ALAMITOS RIDGE SUPPLEMENTAL EIR
PROJECT ANALYSIS, EIR ERRATA, AND
RESPONSE TO COMMENTS

LONG BEACH, CALIFORNIA

February 2004

Volume 3B. Response to Comments

FIGURE 3.3

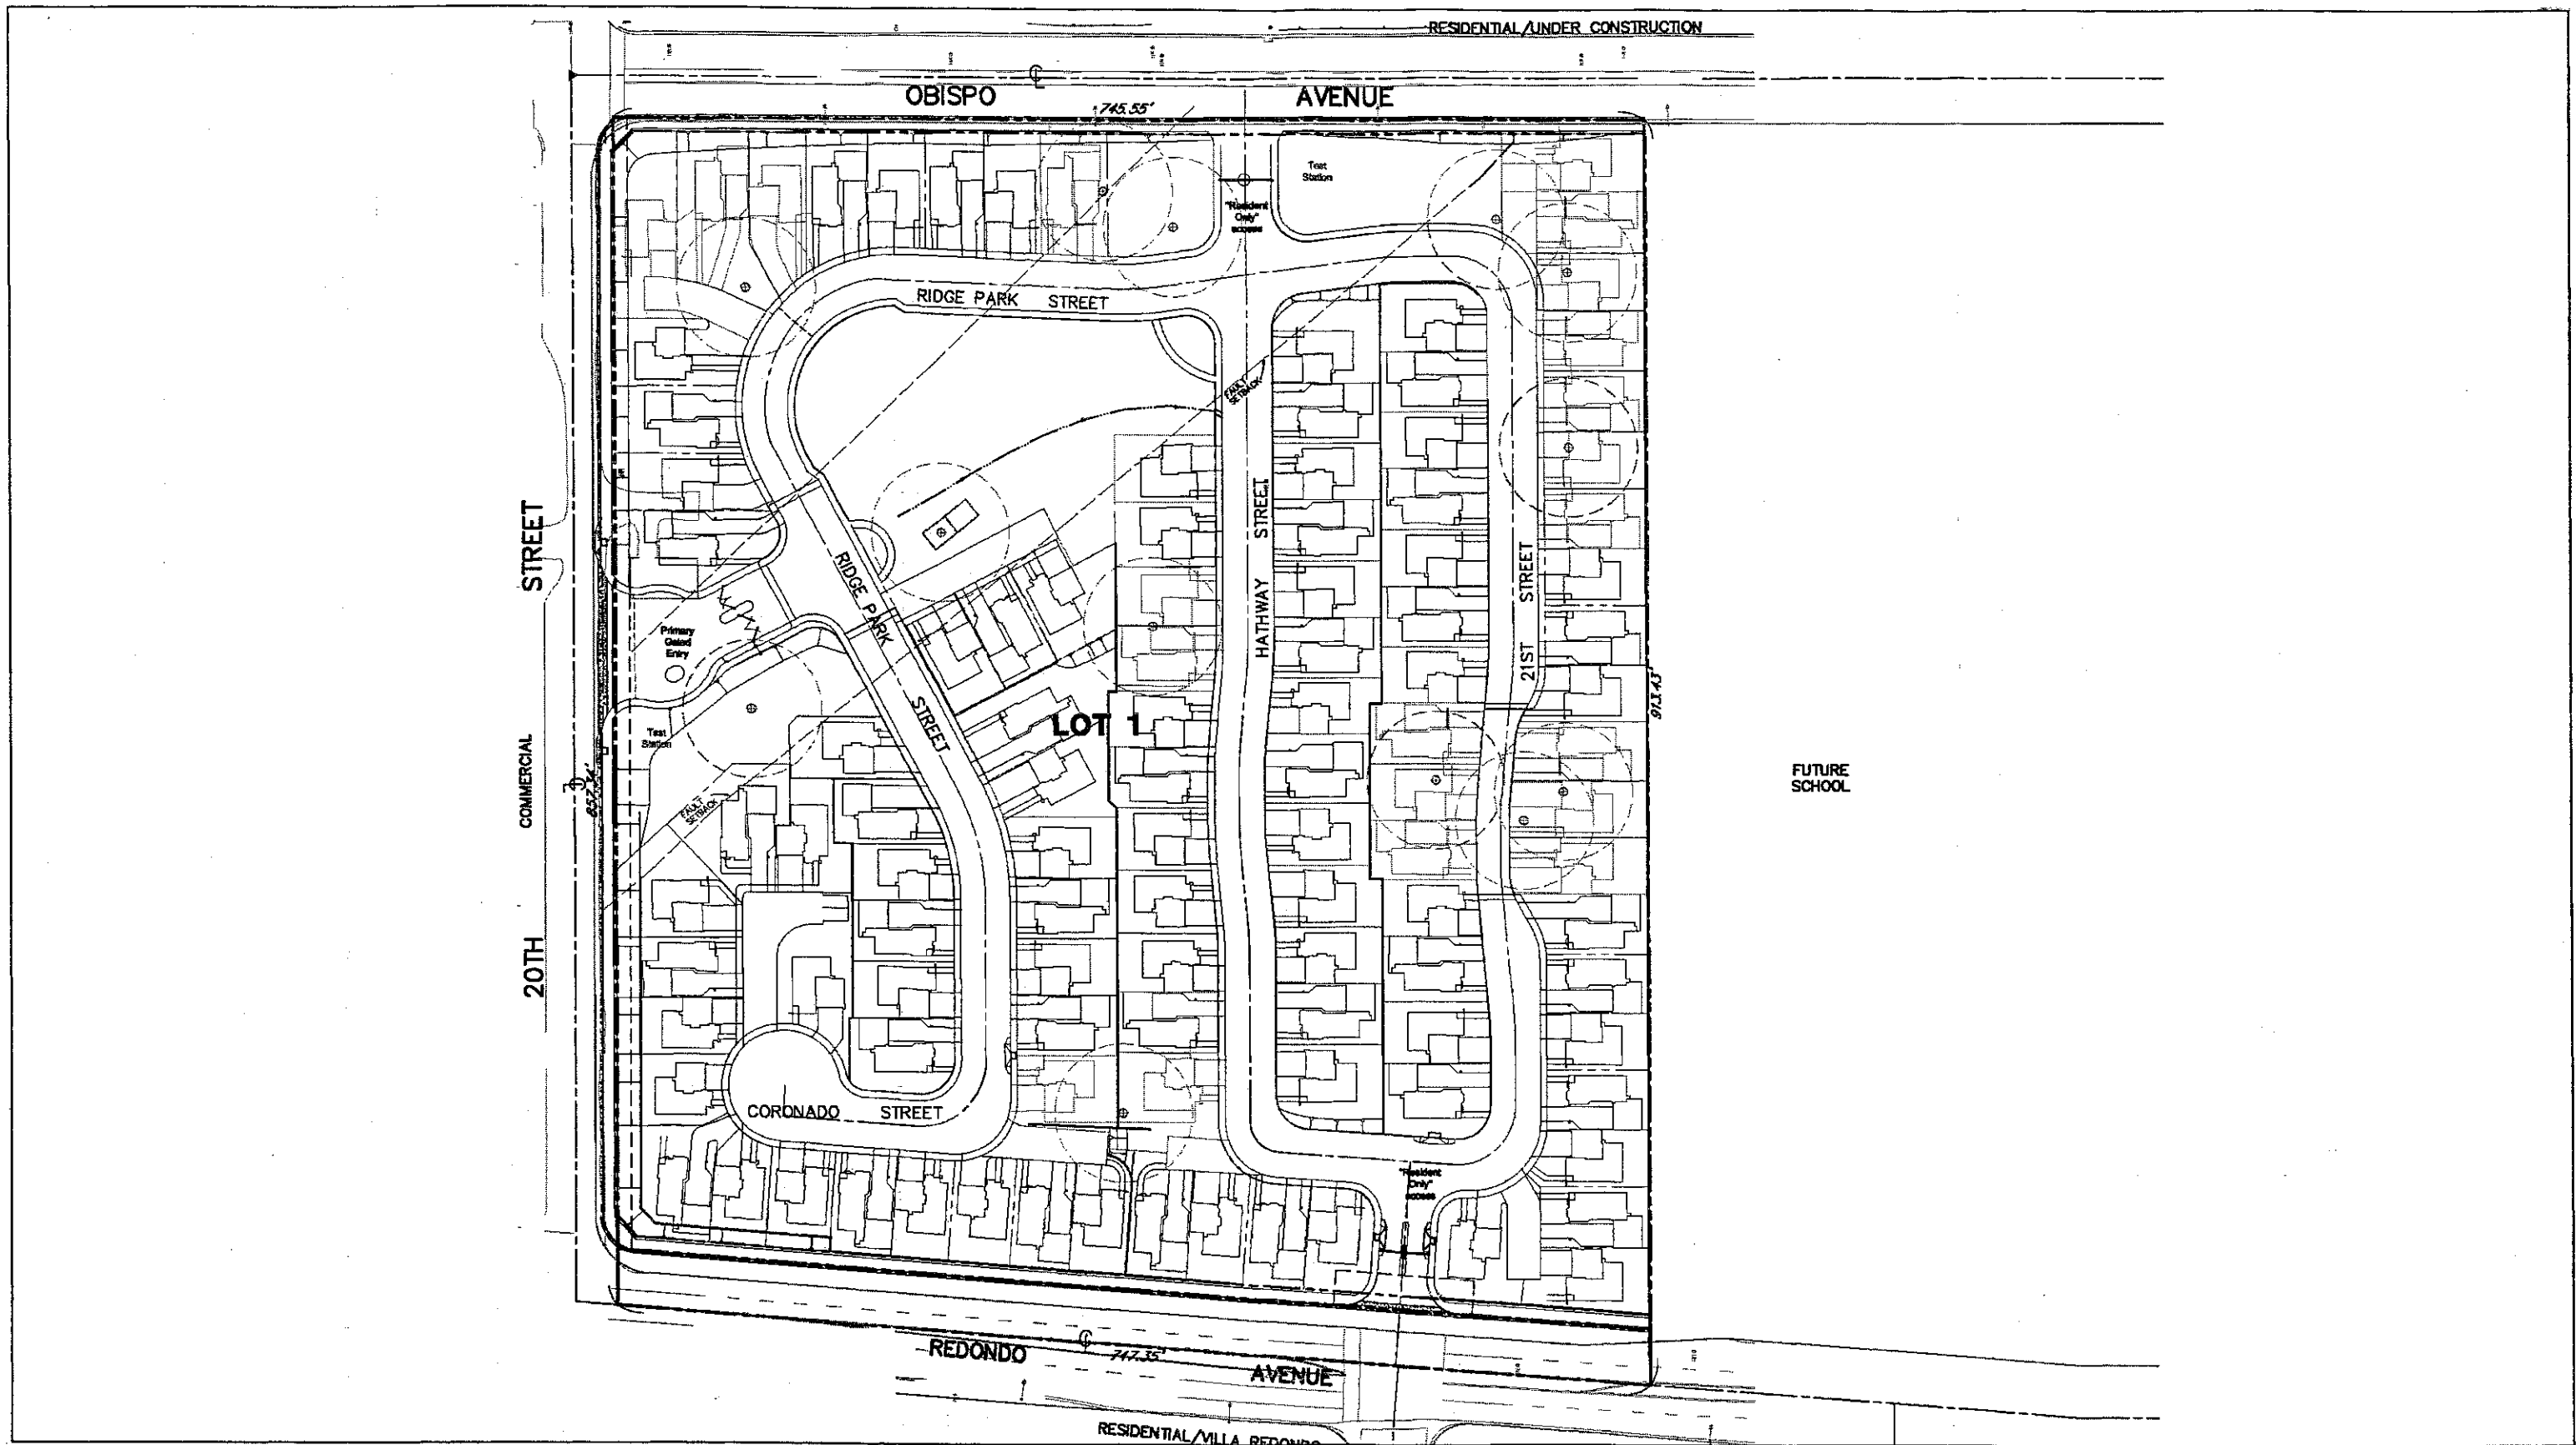
| 9. Page 3-10, Softscape/ Landscape Elements | Figure 3 does not depict the landscape concept. The project does not appear to include "meandering open space edges". The width of the landscaped perimeter edge is substandard for this size residential project site. | G-7 |

- G-1 Comment acknowledged. The requested information is included in the Draft EIR, Section 4.13, and Appendix F, Remedial Work Plan.
- G-2 Comment acknowledged. The requested information is shown in Figure 3.4, Phase I Interim Site Plan, and described on the top of page 3-13 of the Draft EIR. Additional information regarding oil well reconstruction/abandonment/relocation is included in the Errata for informational purposes at the request of the City of Signal Hill. This additional information does not alter the analysis of impacts in the Draft EIR and does not change the conclusions of the analyses, and no additional significant impacts result from this additional information. See also Response G-9 regarding missing insert.

FIGURE 3.4

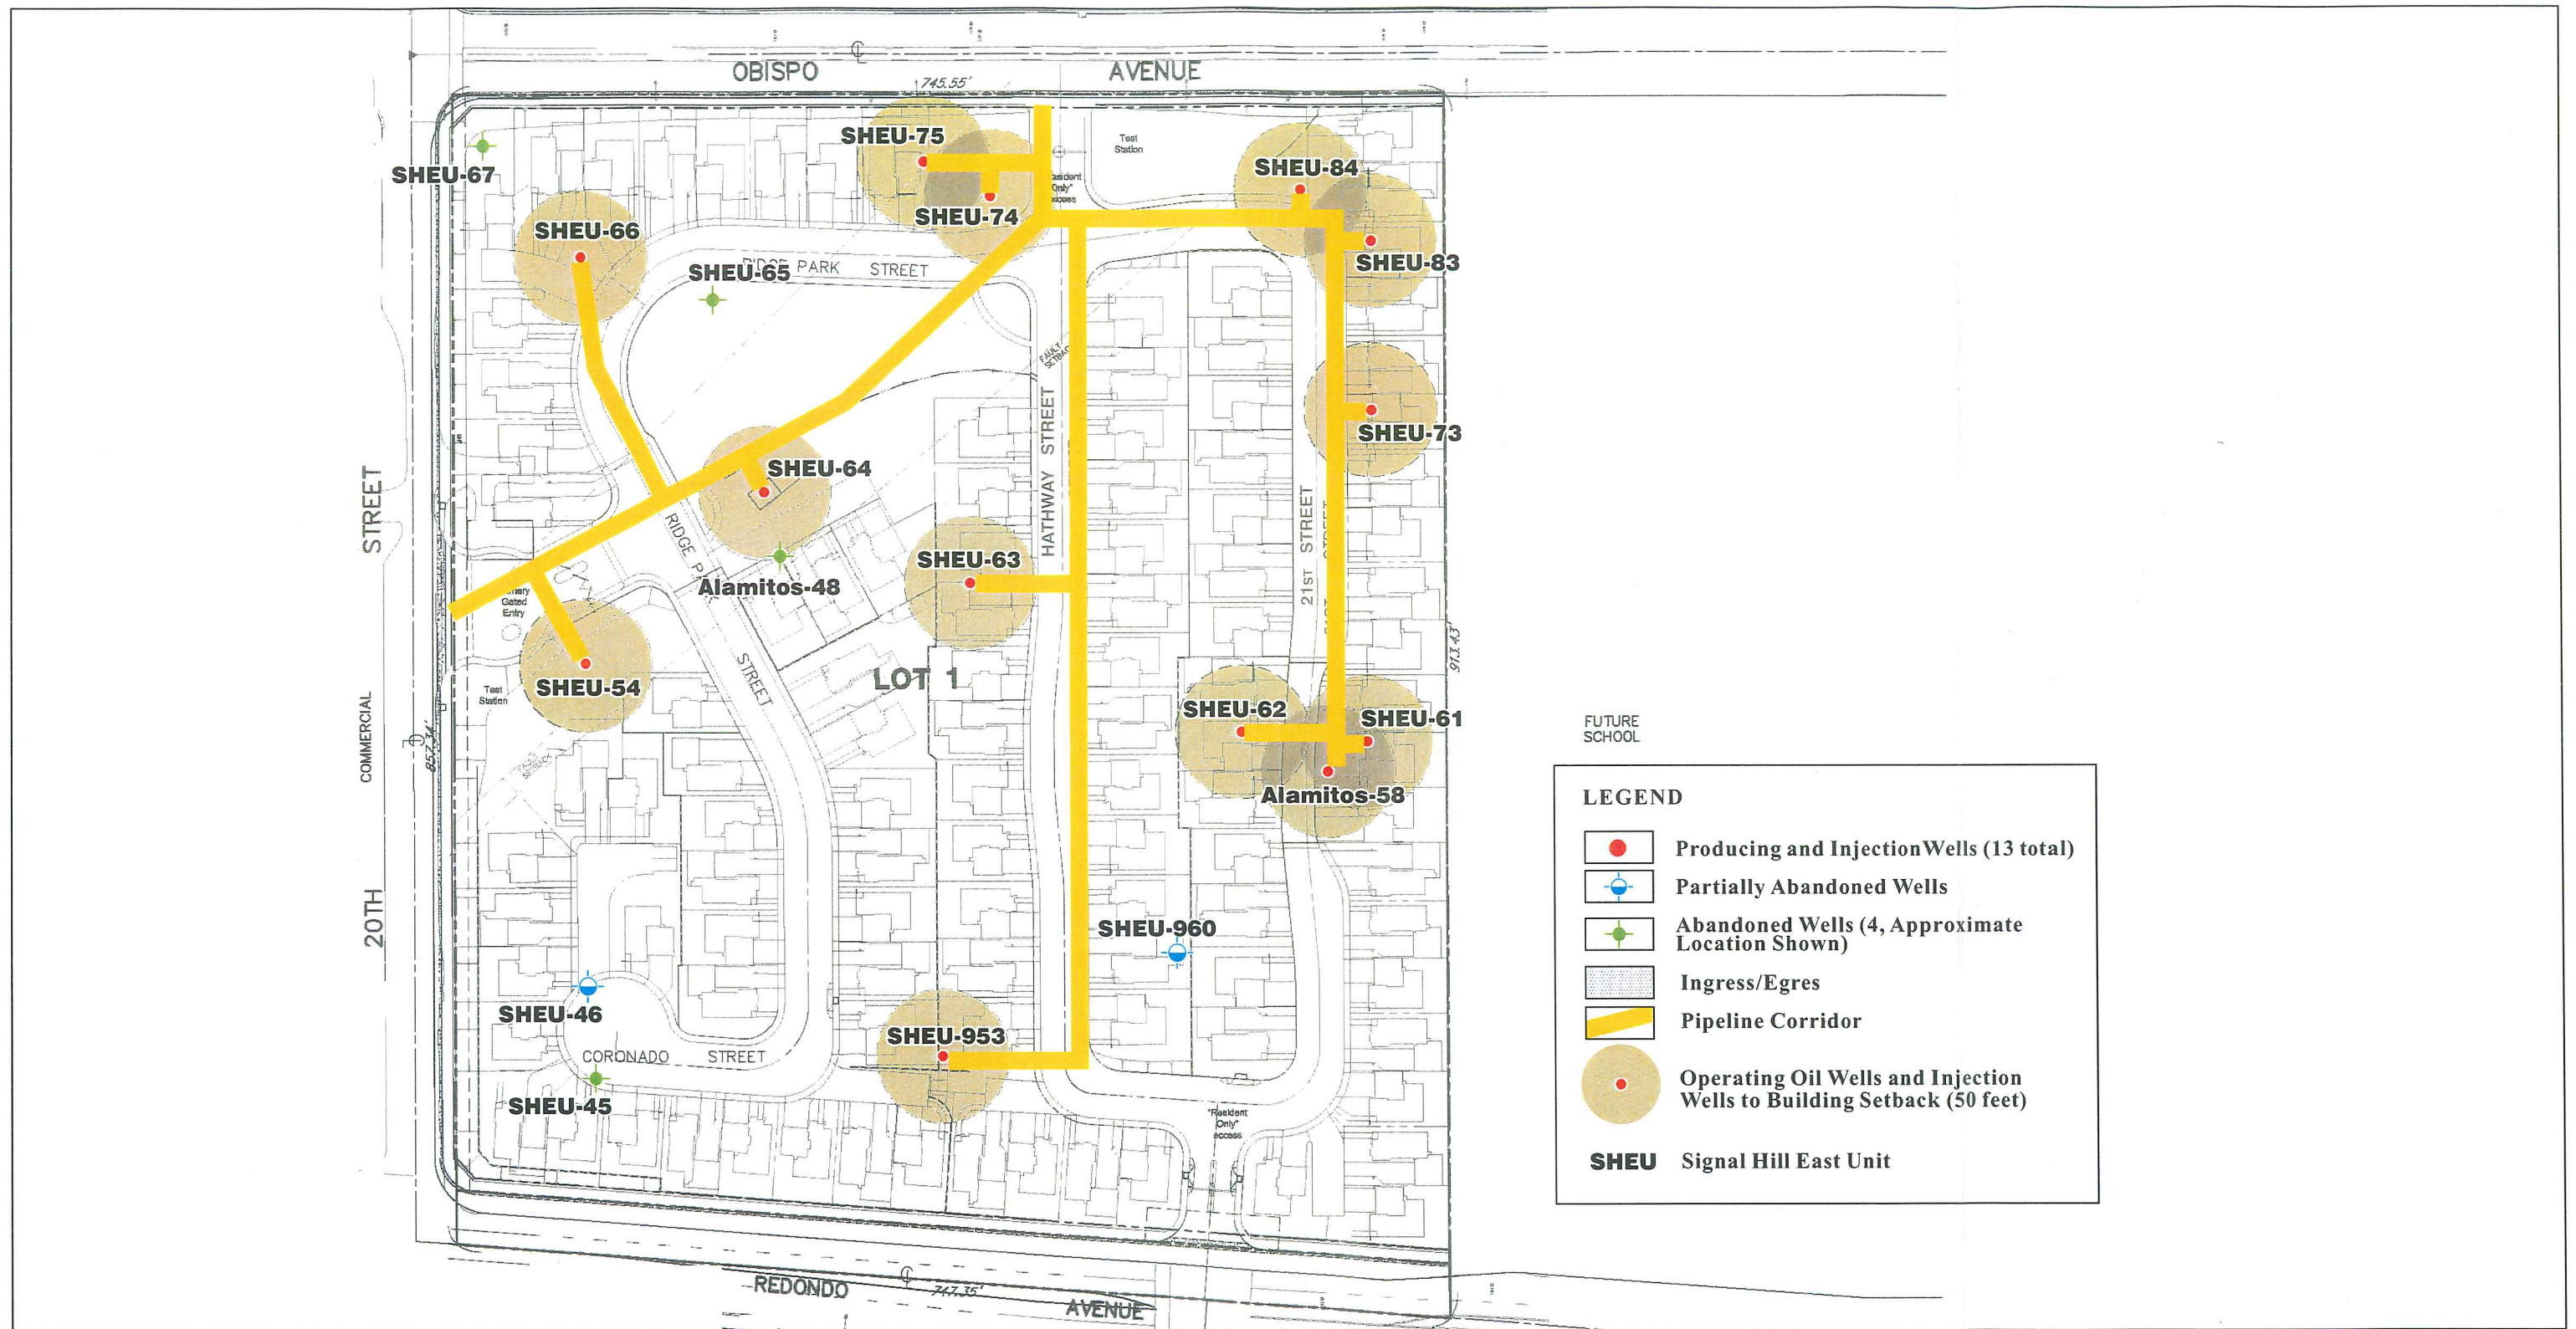
| 13. Page 4.1-14 last paragraph, | same comment as comment 10 Figure 3.4 is not an "Interim Site Plan". | G-11 |

FIGURE 4.4.2

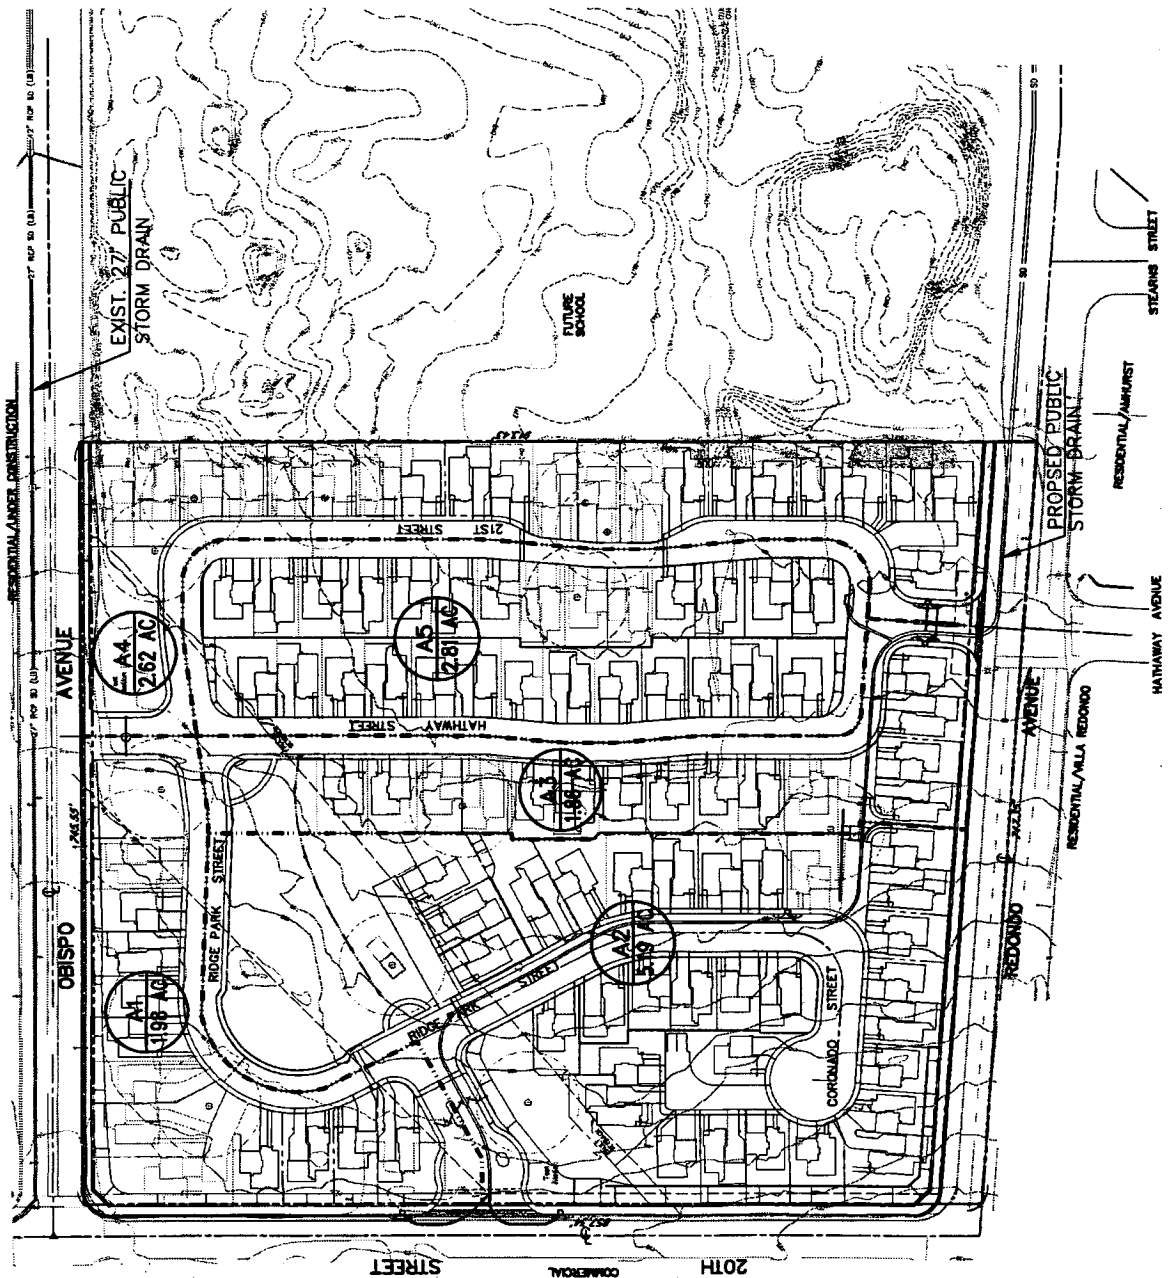
Page 4.4-6, paragraph 4: In the developed condition, the site will be composed of ~~six~~ five drainage areas (Figure 4.4.2). Areas A1, A2, A23, A4, and A5 will drain via a series of catch basins to a new storm drain line along Redondo Avenue, which will connect to the existing 57 inch storm drain located on Hill Street. ~~Area B1 will drain via a catch basin to an existing 27 inch storm drain on Obispo Avenue. Area E3 will drain west along 20th Street and north on Obispo Avenue to the existing storm drain and will not affect the site.~~ Table 4.4.B provides calculated flows for the ~~six~~ five areas during a 10 year storm. Although there is a slight height differential between the project site and the adjacent school site (approximately nine feet), all site drainage will be directed towards Redondo Avenue and is not expected to direct surface runoff towards the school site.

Page 4.4-7: Revised Figure 4.4.2
